Date: May 5, 2020  
File Name: Mississippi River Vista  
File Number: 19-084-032  
Location: 104 North Mississippi River Blvd.

Purpose: Written Public Comment to the City Council in Response to Staff Report and Recommendation for the Final plat For Mississippi River Vista

From: Marian Biehn  
83 Otis Ave  
St Paul, MN 55104

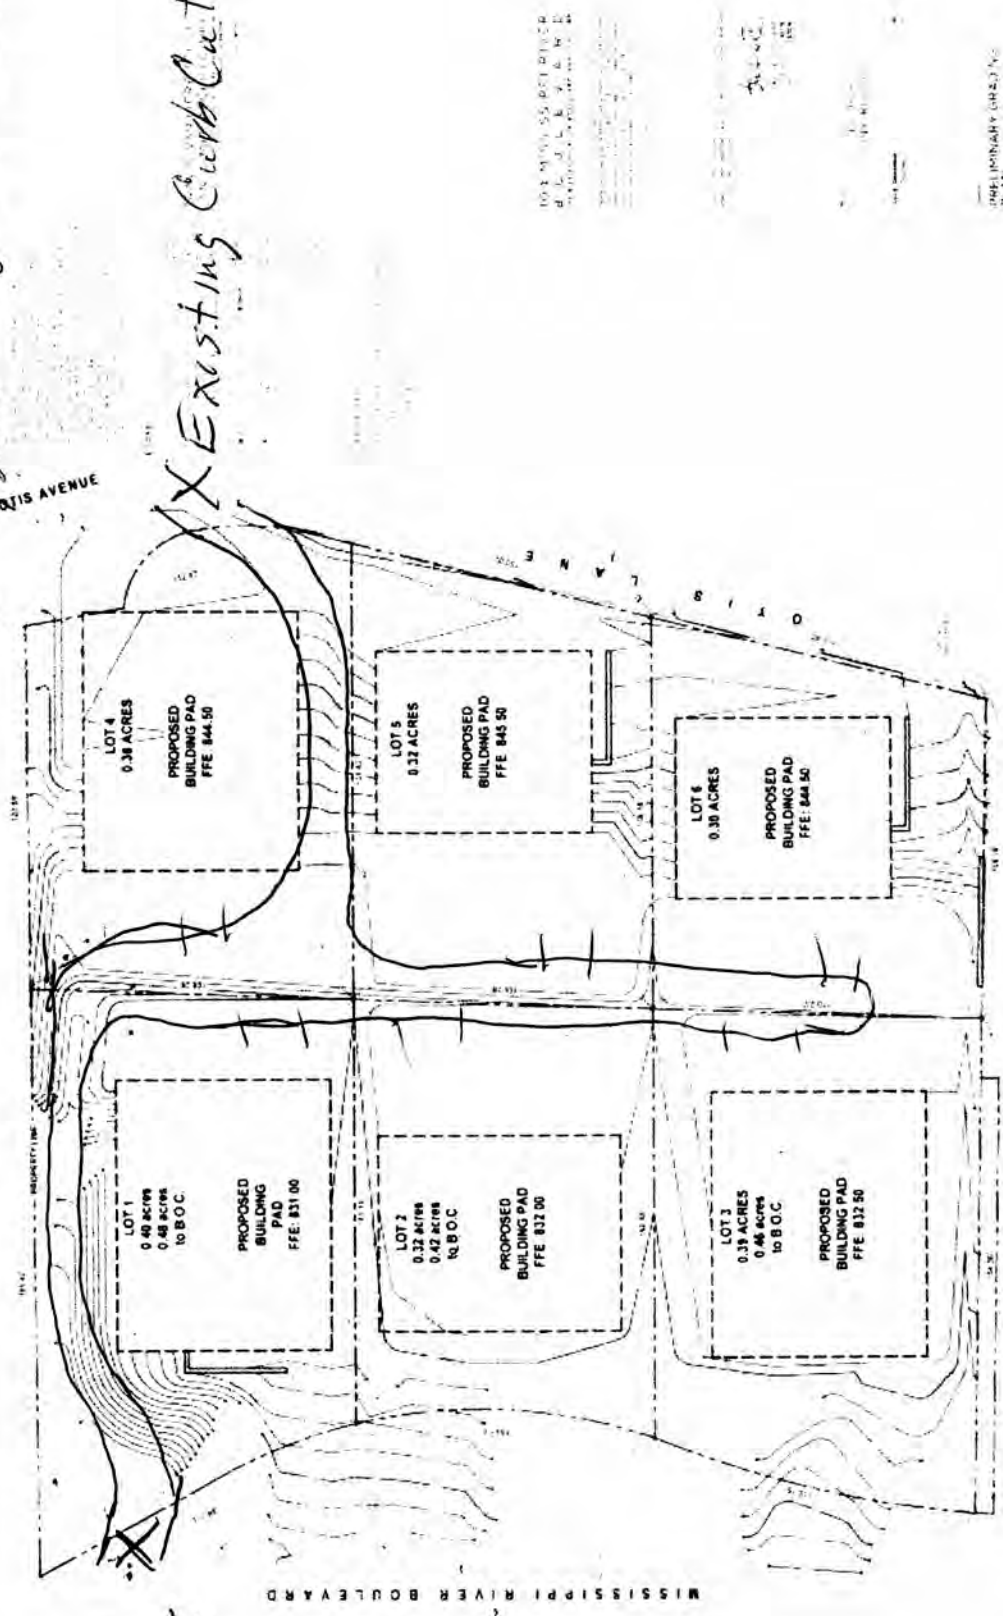
The developer and the City are proposing 2 residences on what they are identifying as facing Otis Lane. Otis Lane enters from the East where there are 3 existing homes. No other homes face Otis Lane. The street is wider at that southern point though still narrower than the current standard for street width. As it turns to the North, it changes both in surface paving and also in width. The street in front of the proposed homes at the north end do not conform to the Standards stated above and is significantly narrower than standard local street width. When did the north end of Otis Lane become an official street or lane? Who designated it as such and when? It is not wide enough to be nor is it paved as a standard street. (Attached photo of 18' measure of the Otis service drive)

*(b) If Otis is to be considered an alley, it barely meets the standards. Otis Lane enters from the east and turns to the north and narrows into a service drive at the rear (west side) of 79 Otis Ave. At the rear (Otis service drive side) of 79, 83 and 97 Otis Ave, the drive is only 18' wide (NOT 20' as identified on the map) and is the driveway access for 4 existing homes. The width is less than Residential Right of Way width for alleys as identified in the Zoning Code for Subdivisions 69.502b and much less than the Local Street width minimums.*

Alternative Re parceling with existing curbcuts

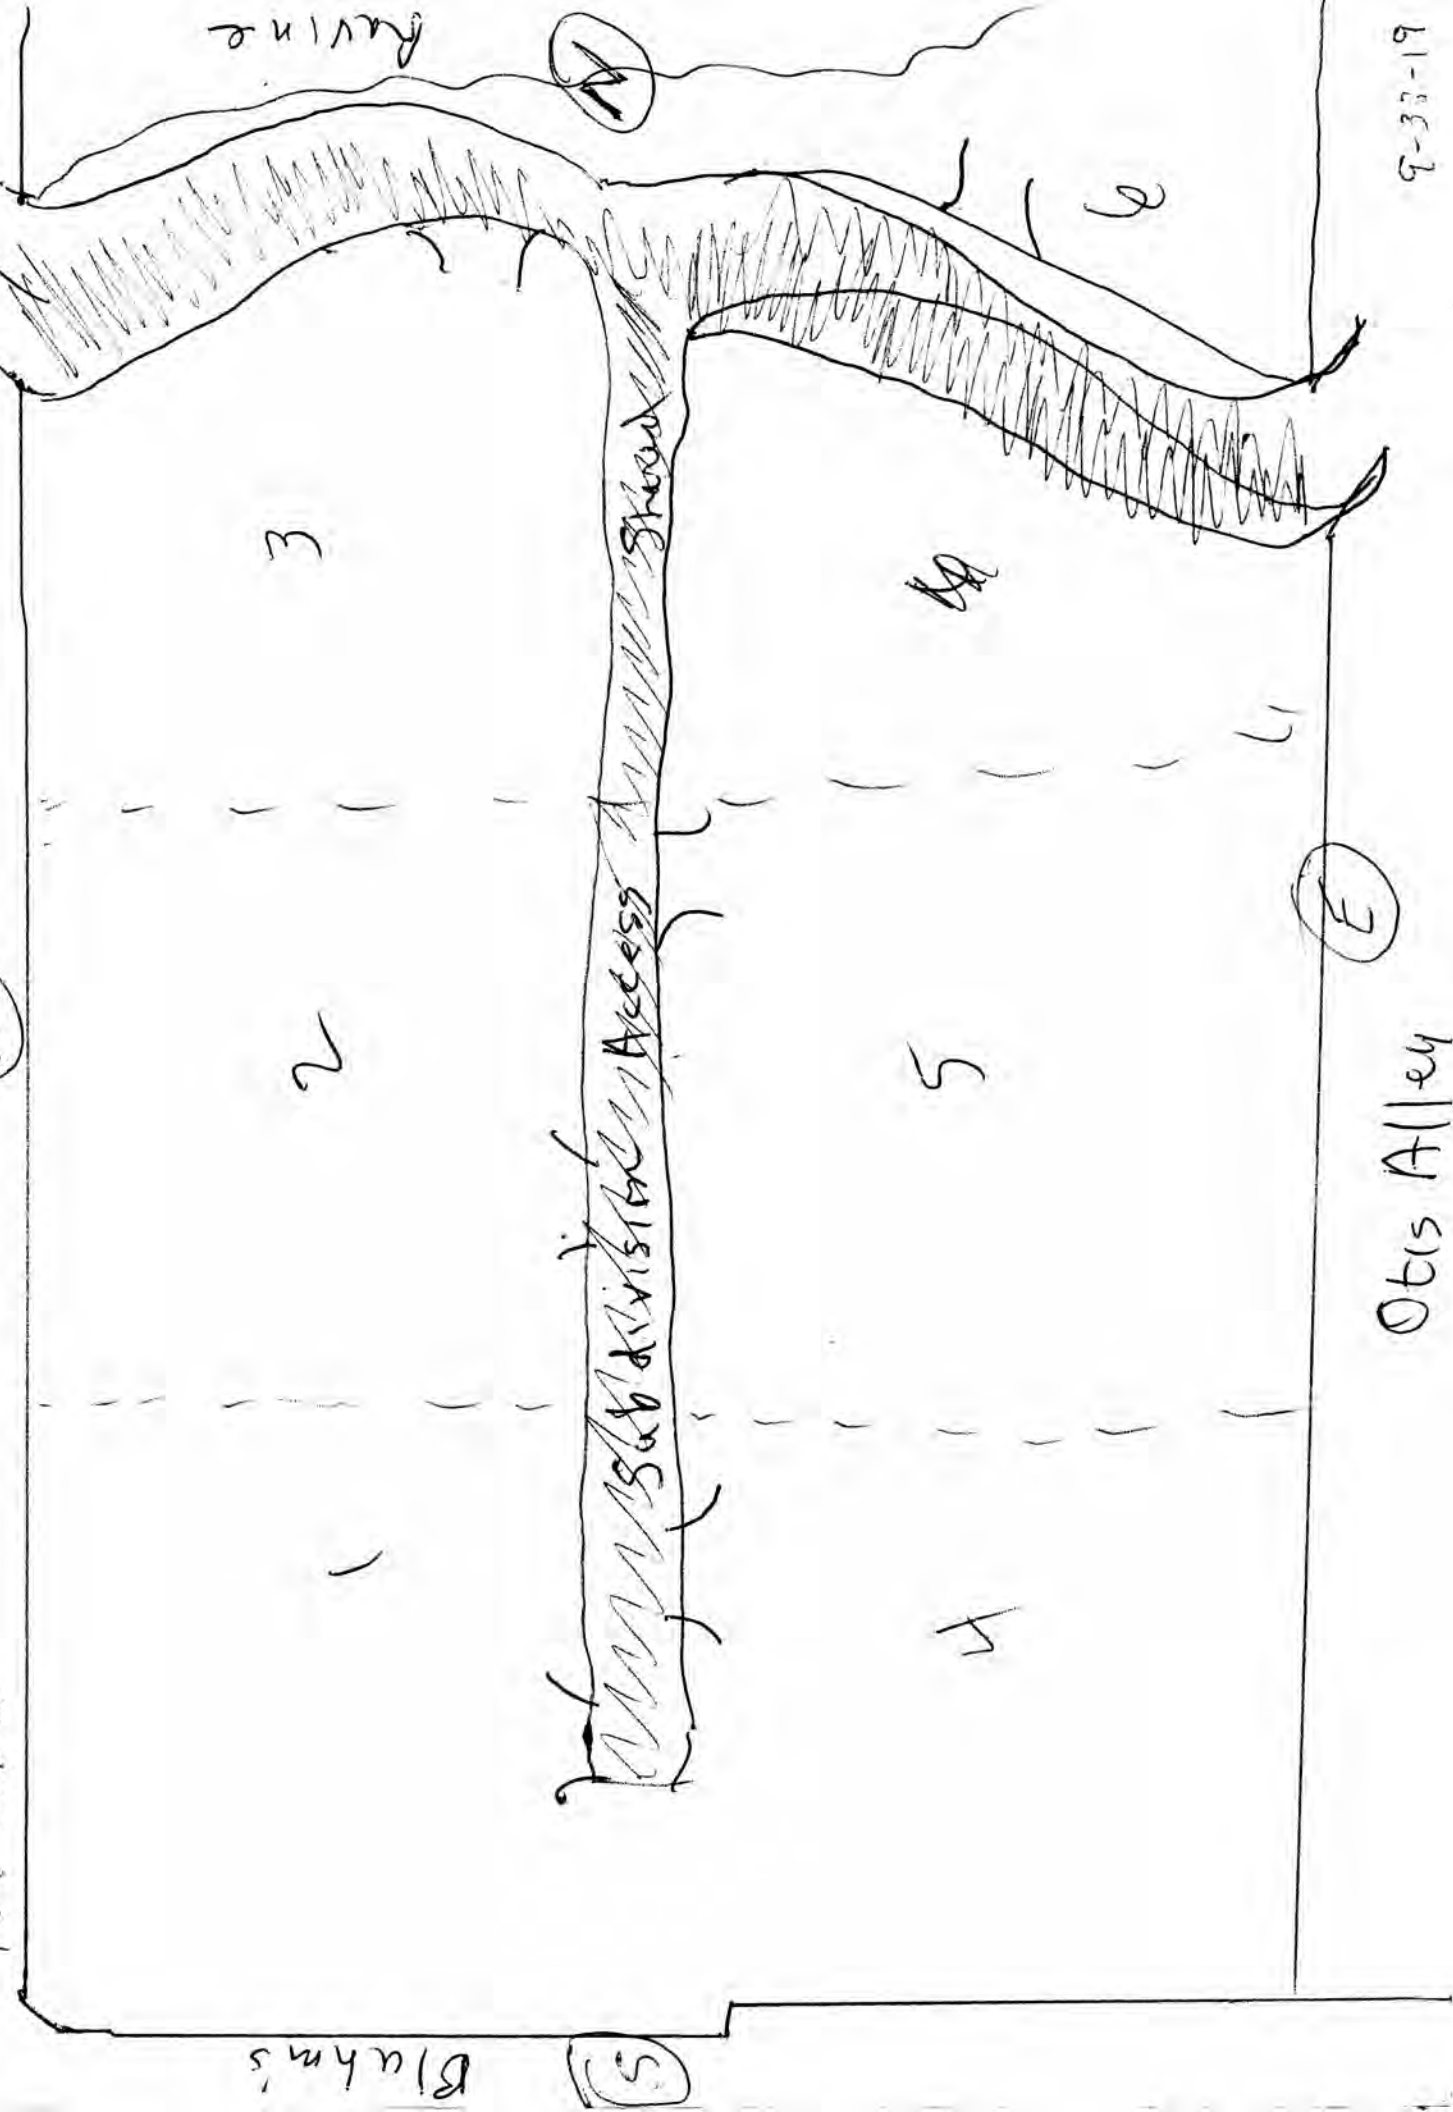
**Issue 1 Traffic, Access, Safety:** I am asking the City Council to consider an alternate access and circulation plan for the site to service the 6 proposed parcels. Or at minimum, a reduction of curb cuts on what is identified as Otis Lane. I have attached a very elementary drawing of how a shared access would be incorporated and the rationale with supportive St Paul Zoning text and addressing the findings.

If only one access point or curb cut is allowed from Mississippi River Boulevard, I am asking that it be incorporated as a share drive for the 2 or 3 potential residences planned for MRB. Similarly, I am asking that the existing curb cut/access from Otis Ave be reutilized as an entrance and egress for the 3 houses proposed for Otis Ave and Otis service drive. And finally, that a common drive aisle be incorporated at the rear of all the homes to reduce impermeable paved area, provide additional self-contained subdivision parking and service provider access, and remove the 3 proposed curb cuts along the Otis service drive. A legal easement can be established with use and maintenance guidelines. A central drive aisle might also alleviate the need for the proposed increase in elevation along the Otis service drive. (Attached rough illustration of single access from MRB & Otis Ave and shared drive aisle)

104 Mississippi River Blvd/Mississippi River Vista is considered a new subdivision. I suggest that some of the old features should be implemented or grandfathered in. Though not obviously a "Trough lot" the previous single use of 104 MRB was a through lot. I am asking that the Council consider the following: 1- a single shared access for the 2 or 3 proposed homes on MRB and a single access for the 3 proposed homes on Otis Ave and service drive; 2- the possible addition of a small accessory, shared parking area contained within the subdivision for the home owners; and 3- a shared, central drive aisle at the rear of the houses. With the added density of the plan and the limited access off MRB, the current proposal unfairly intensifies and concentrates the access off the much narrower Otis service lane. The Through Lot and Lot Access provisions should be implemented for this site creating safer access and use, better circulation and reduction of impermeable surface. The suggestion of adding a small parking pad for use by the home owners addresses the lack of parking on MRB and removes the danger of owners, visitors and services parking along the 18' wide Otis service drive.
